MODEL BENTLEY MARK VI

MODIFICATIONIGNITION COIL INPUT SUPPRESSOR

Bulletin

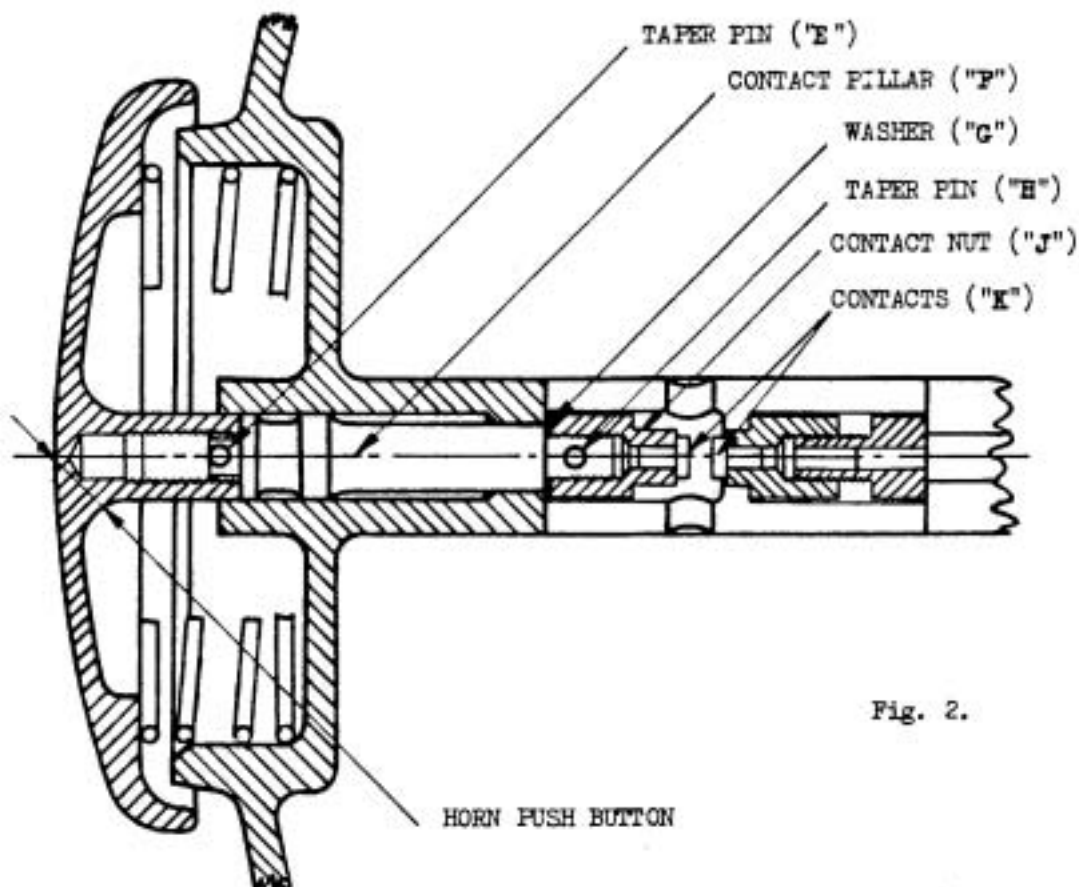
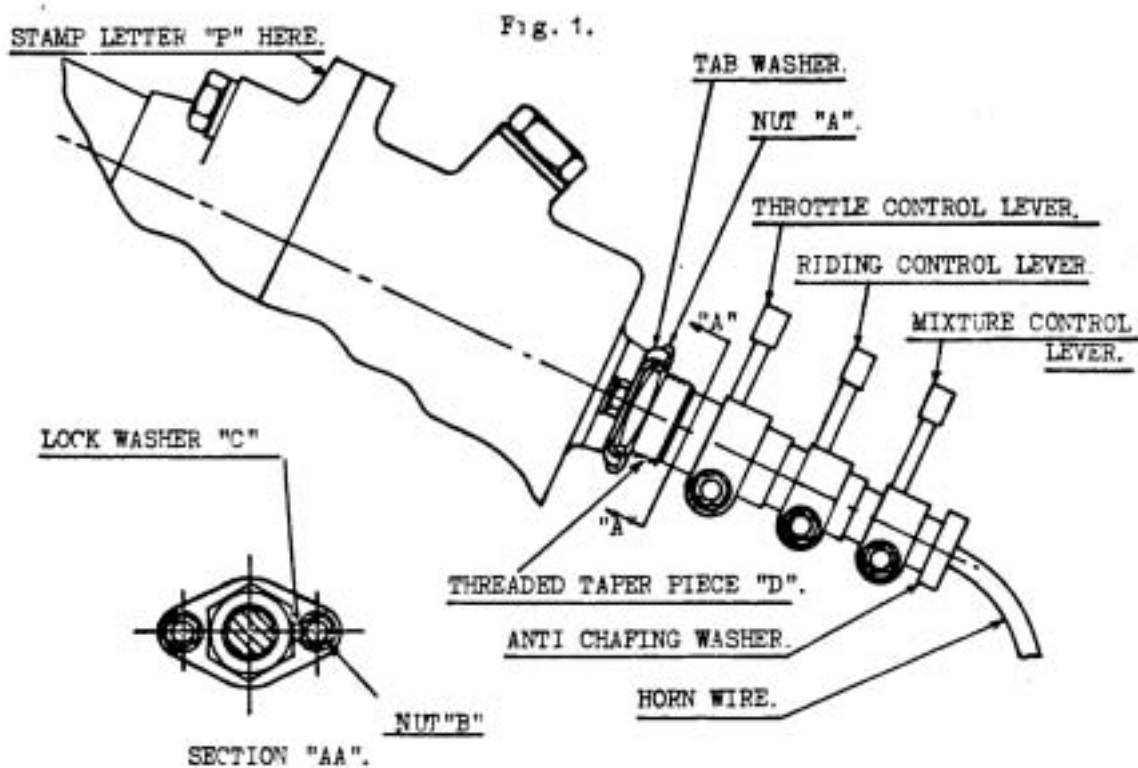
A modification is introduced to the horn push button assembly to give additional strength where the contact pillar is screwed into the horn push. The alteration consists of the substitution of the taper pin locking by sweating.

A new contact pillar, with its top threaded portion tinned with solder is screwed and sweated into the push button.

A distance of .040" between the contacts is desirable, and this is obtained as follows:-

The amount of this travel is regulated by the thickness of the brass washer 'G'. If the horn sounds before the button nips the feelers, the brass washer requires reducing in thickness, but if a greater travel than .040" is obtained before the horn sounds, then a thicker washer is required.

When the correct amount of travel is obtained, the contact pillar is drilled through the existing holes of the contact nut 'J' and the taper pin 'H' fitted. The unit may now be finally refitted in the steering wheel hub.

RUN OF WIRING, POSITION OF CLIP, RUBBER SLEEVES AND SUPPRESSORS.CARS ON WHICH MODIFICATION ACTION IS NOT NECESSARY:

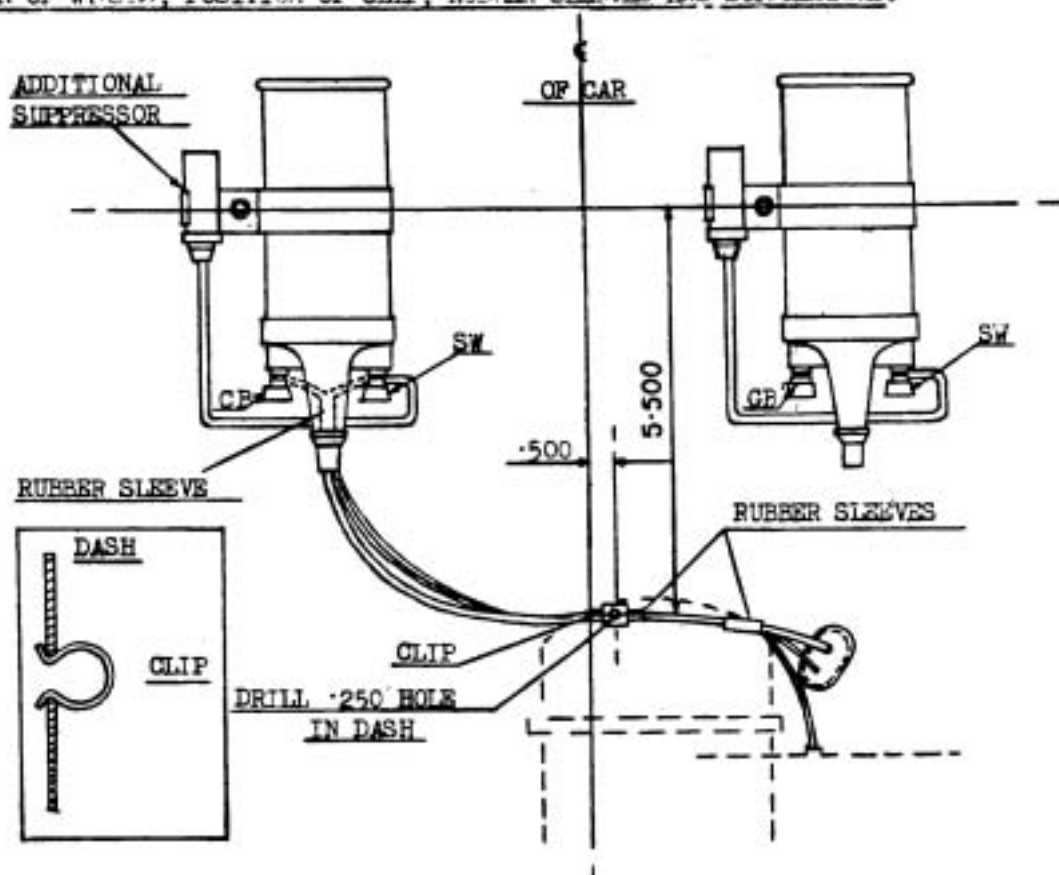
A modification is introduced to obviate the necessity for moving the existing ignition coil suppressor condenser when the spare ignition coil is being used. In conjunction with this modification, a clip is fitted to the dash to group the coil wires together and rubber sleeves to the wires to prevent chafing.

This is to be fitted to the off-side fixing bolt of the off-side ignition coil bracket and the suppressor lead connected to the INPUT (S.W.) terminal of the coil.

A hole .250" diameter should be drilled through the dash at the point indicated in the attached drawing. This position is immediately behind and on a level with the top of the rocker cover which can be removed to facilitate drilling the hole. The rocker gear should be covered to prevent the entry of swarf during the drilling operation. The drill should not penetrate the dash more than 5/16" as this will cause damage to the insulation situated immediately at the rear of the dash.

These should be positioned on the wires as shown in the attached sketch. The wires should be connected to the off-side coil, the radio switched on and the engine run to check the suppressor and the ignition coil for correct functioning. The wires can be left connected in this position, the near-side coil becoming the spare.

FIG. 1. STANDARD HEADLAMP WITH LIGHT UNIT REMOVED.

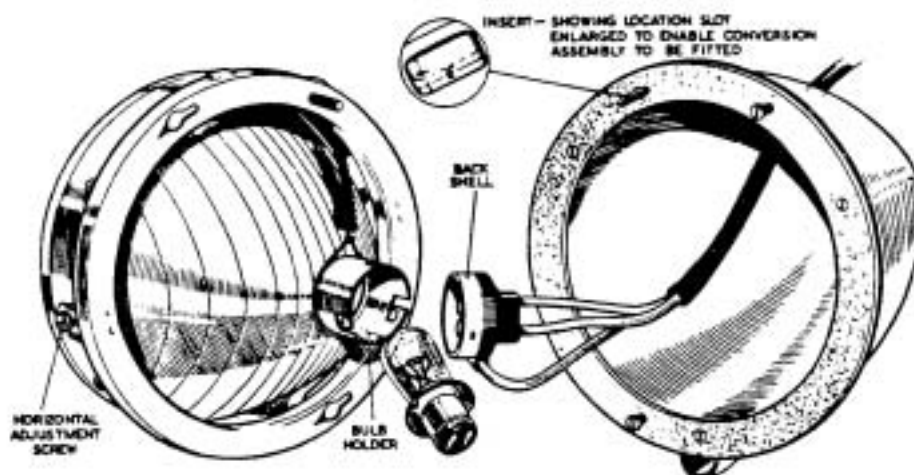
- (i) Remove the front rim by slackening the single securing screw.
- (ii) Slacken the screws in the flange of the Light Unit and turn the Light Unit in an anti-clockwise direction to detach the flange from the securing screws. The Light Unit can now be lifted out of the lamp body.
- (iii) Remove the back shell by twisting in an anti-clockwise direction and cut off the cables at the back shell.
- (iv) The Light Unit assembly and back shell can now be discarded.

- (i) Remove the plated unit rim from the seating flange by taking out the two horizontal adjustment screws.

FIG. 2. CONVERSION ASSEMBLY FITTED.

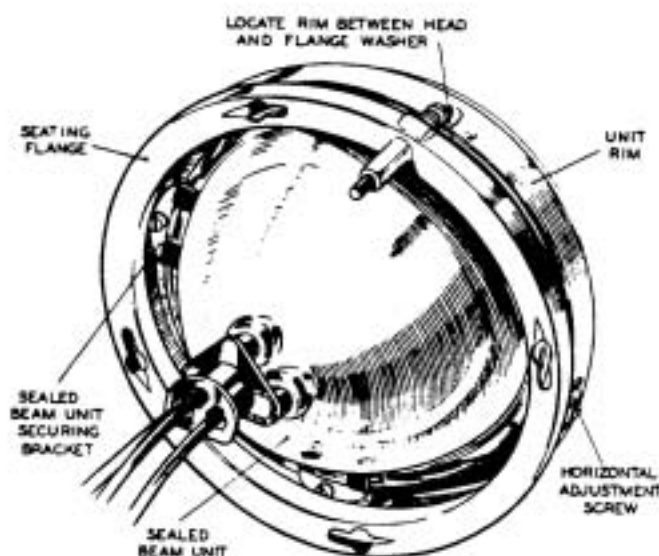
Connection to the Sealed Beam unit is made by means of a three point adaptor plug. To make the connections, proceed as follows:-

- (i) Bare approximately $\frac{3}{8}$ " of the cables.
- (ii) Remove the adaptor from the Sealed Beam unit.
NOTE: It will be observed that the rear of the adaptor is marked "Ground", "Pass" and "Drive".
- (iii) Remove the three spring contacts from the adaptor.
- (iv) Solder the core of the black cable to one of the spring contacts and fit the contact in the recess of the adaptor marked "Ground".

FIG. 1.

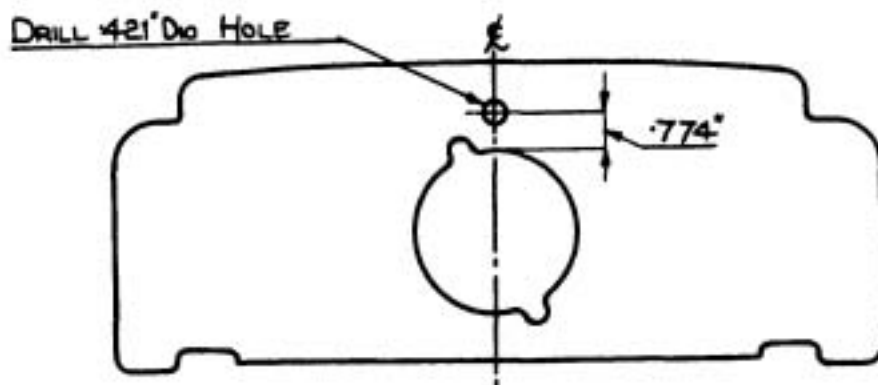
4. Fit the switch supplied into the vacant hole in the top of the instrument panel above the switch box. If this hole does not already exist, drill as shown in Fig.1.

FIG. 2.

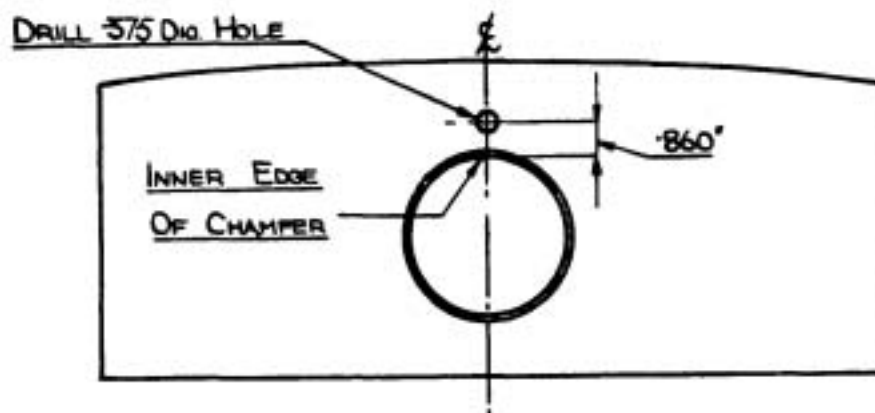
5. Drill the wooden fascia panel as shown in Fig. 2.

FIG.1. DRILLING INSTRUCTIONS FOR FACIA PANEL.

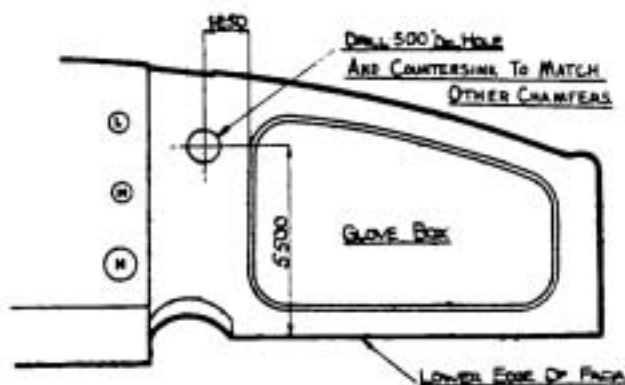
1. Mark off and drill the fascia panel to the dimensions given in Fig.1.
2. Connect bridge piece (RH.303) between terminals 2 and 4 as shown in Fig.2.
3. As it is impracticable to supply a mounting bracket to suit a variety of mounting positions it is left to the discretion of the Retailer as to what method he uses to secure the switch.

FIG.2. WIRING DIAGRAM FOR PETROL PUMP SWITCH.

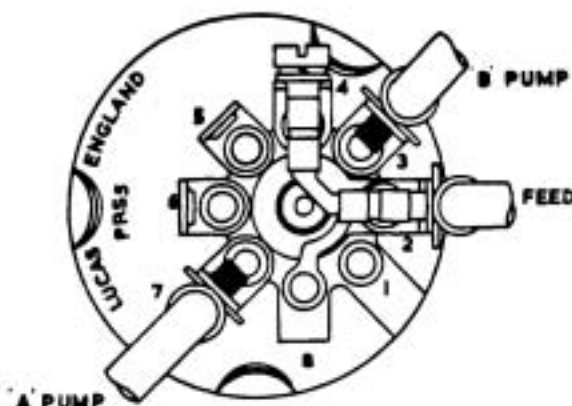
5. Run two wires from the petrol pump switch through the metal cable conduit to the existing twelve-way junction box located immediately above the fuse box. Connect these two wires to vacant terminals.

6. Remove and discard the short length of wire fitted between the rear and front petrol pump terminals, and then disconnect the cable running from the pumps to the fuse box. Connect a length (6' 6") of new cable to each of the pump terminals, and then feed these cables through metal conduit up to the twelve-way junction box. Wire the pumps to the two terminals carrying the petrol switch connections, ensuring that the forward pump is wired to the terminal corresponding to 'A' on the pump switch and the rear pump to the 'B' terminal as shown in Fig.2.

FIG.3. DRILLING AND FIXING - JUNCTION BOX.

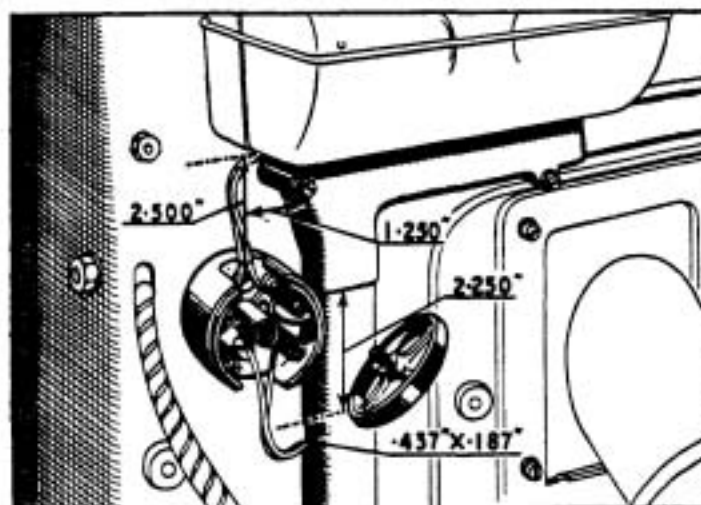
3. Feed the two leads from the petrol pump switch through the conduit and below the fuse box, and connect up to two of the terminals in the additional junction box.
4. Cut an aperture $7/16'' \times 3/16''$ in the side of the conduit, and draw the two leads from the petrol pump terminals through this up to the junction box. Connect lead from the forward pump to the terminal carrying the "A" connection, and the rear pump lead to the terminal carrying the "B" connection from the petrol switch. Replace the junction box cover.

FIG. 1.

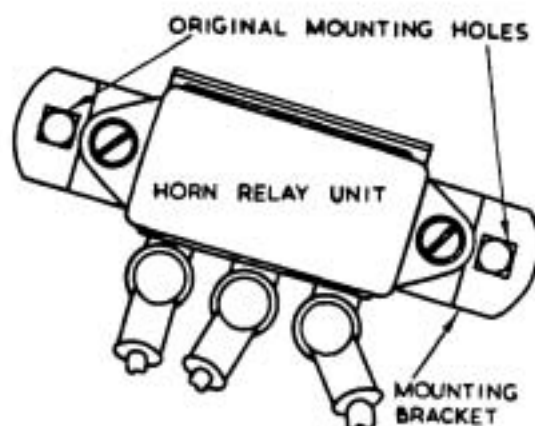
Retailers are advised that the Lucas C585K horn relay unit (Part No. RD-3084) as at present fitted, has been superseded by the Lucas SB-40 type unit (Part No. RD-6351), and that this is now the only replacement available.

Fig. 1 illustrates the general arrangement of the new assembly when installed on a car.

- 1) Remove the cover and disconnect the cable assemblies from the existing horn relay unit. Remove the relay unit from the valance plate.
- 2) Fit the new mounting bracket (RD-6352) to the valance plate, using the two shorter 2BA bolts supplied. Mount the replacement relay unit on to the bracket using the two 2BA cheesehead screws supplied.
- 3) Reconnect the cable assemblies to their respective terminals on the new relay unit.

FIG. 2. DRH.8859 CONDENSER
(Current Replacement)

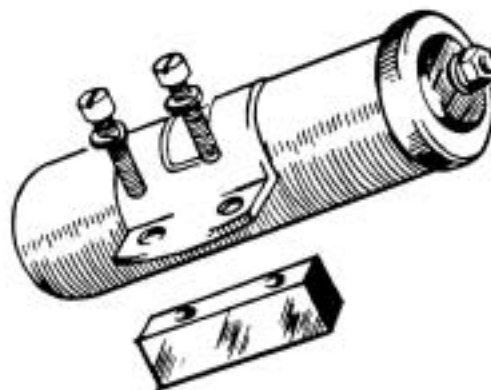
The ignition condenser (Delco-Remy Type DRH.1386, Part No. RD.6258) hitherto fitted on all chassis in production has been superseded by the improved DRH.8859 type unit, which is now the only replacement available.

Although the new type condenser is interchangeable and is fitted on the distributor in a similar manner to the original unit, it will be observed from the above illustrations that a distance piece is also included. This is due to the difference in the relative angular setting of the mounting bracket.

FIG.1.

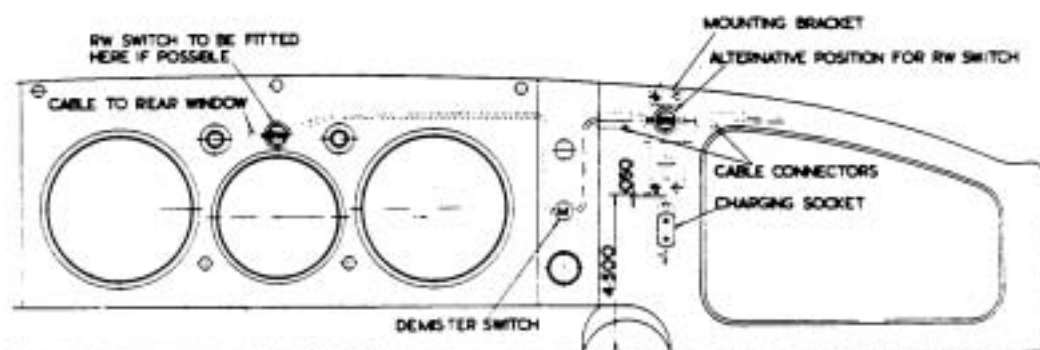
(iii) Fit the RW switch to the centre vacant hole in the instrument panel or fit the bracket and switch to the right as shown in Fig.1.

FIG.2

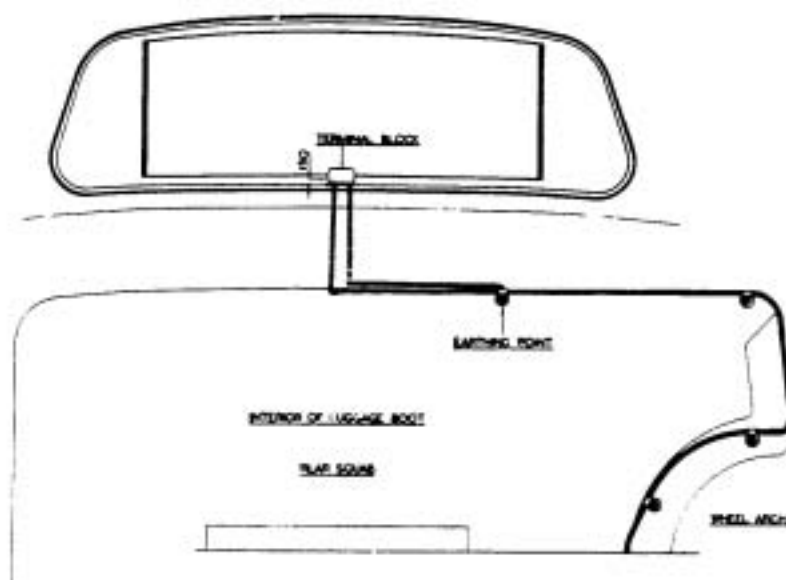
- (vi) Anchor the cable to the squab screws following the line of the boot as shown in Fig.2 and enclosing the cable in P.V.C. tube.
- (vii) Drill two .218" dia. (5.5 mm) holes one on each side of the centre line, 1" between centres, through the rearmost sloping portion of the parcel shelf. Stick the terminal block to the rear window with Durafix symmetrically across the centre line and approximately .150" (3.01 mm) above the top edge of the wooden finisher. When secure attach the demister terminals and the feed wire. Connect a short earthing cable from the terminal block to the centre screw on the top of the rear squab (Fig.2).

Fig.1. DR 3. Type windscreen wiper motor.

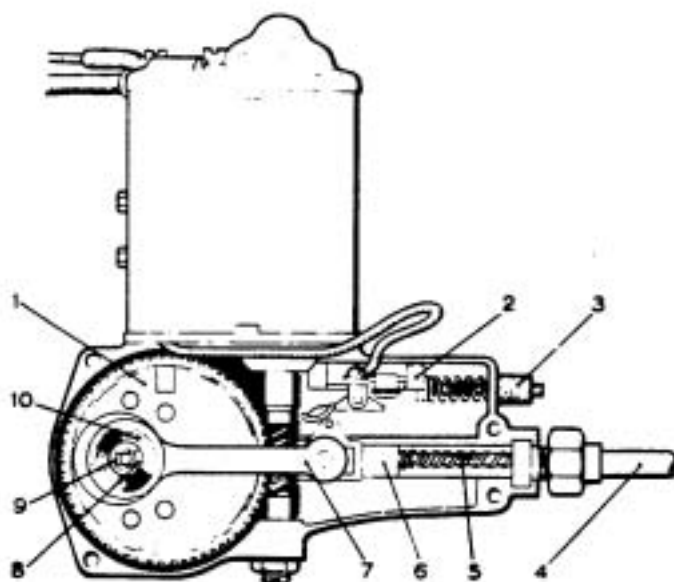
A new wiper motor (DR.3. type) is now being fitted to current production cars and by reason of its greater torque output and modified design, is an improvement on the DR.1. type motor which was fitted previously.

Remove the circlip, which retains the connecting rod followed by the plain washer, conical spring and shaped washer (see fig. 1); care should be taken when removing the conical spring as it is under compression.
